Planning Commission - 779 San Carlos , El Granada

Re: PLN2021-00478 (Lacasia): Consideration of the adoption of an Initial Study/Mitigated Negative Declaration (IS/ND), pursuant to the California Environmental Quality Act (CEQA), and Coastal Development Permit, Design Review, and Variance, pursuant to Sections 6328.4, 6565.3, and 6531, of the County Zoning Regulations, to allow the construction of a new 1,670 sq. ft., three-story, single-family residence with an attached 371 sq. ft. garage and 791 sq. ft. Accessory Dwelling Unit (ADU) on a legal 7,070-sq. ft. parcel, in the unincorporated El Granada area of San Mateo County. A Variance is required to allow a front yard setback of 3 feet where 20 feet is required, due to the site location within the Montecito Riparian Corridor and associated 30-foot riparian setback. The ADU is a ministerial project that does not require review by the Planning Commission. The project is appealable to the California Coastal Commission.

This is in regards to the San Mateo Planning Commission meeting July 23, 2025, agenda item 2, Elizabeth Lacasia file PLN2021-00478, San Carlos Ave, APN 047-105-020

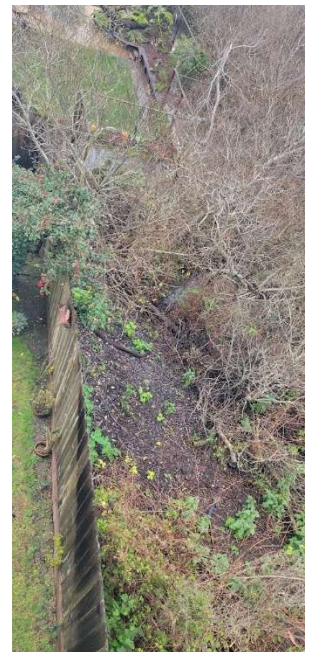
Left - Recent photo showing sandbags lined up below the property on Balboa, in preparation for normal winter flooding. Our small dog Charlie for scale.

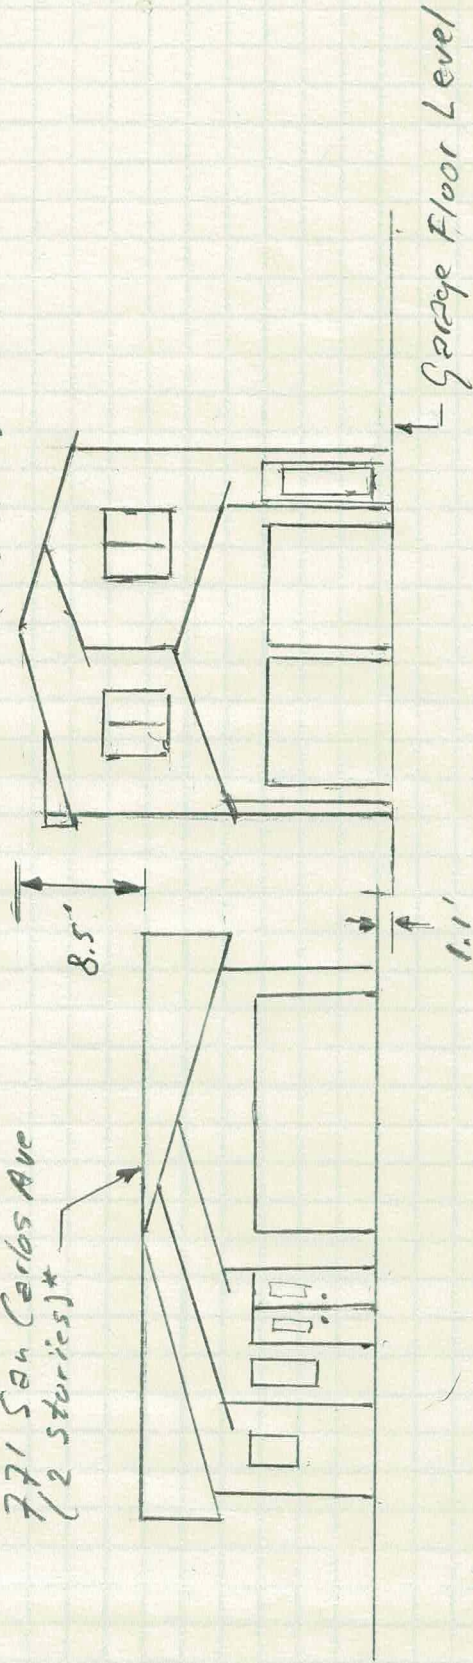
We attached two drawings showing the imposing scale of the proposed house relative to the very large neighboring house. It towers 8.5' above the neighboring house and its garage is approximately 20 feet closer to the road.

Fig 2

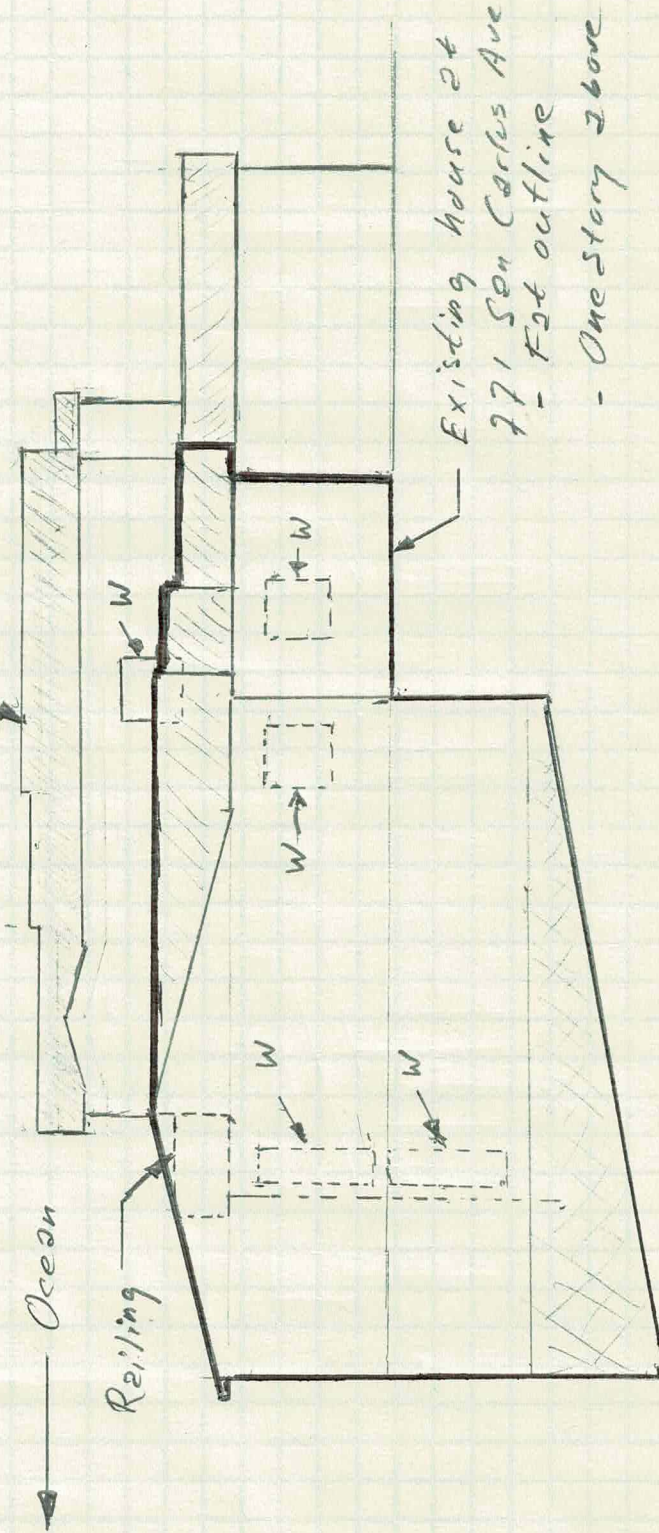
Elevation as seen from street

W = window in
proposed home
facing existing
house
